AUCKLAND UNITARY PLAN INDEPENDENT HEARINGS PANEL

Report to Auckland Council Hearing topic 074 Designations

Transpower Limited

Designations 8507, 8515, 8516, 8517 and 8519 Underground Line and Transition Facilities

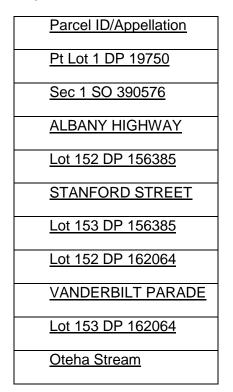
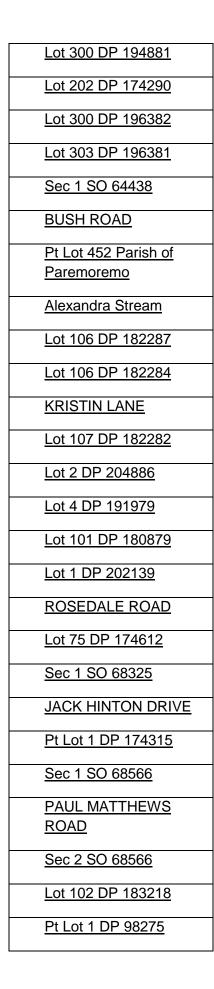
Delete the existing diagram of schedule of legal descriptions and replace it with the following:
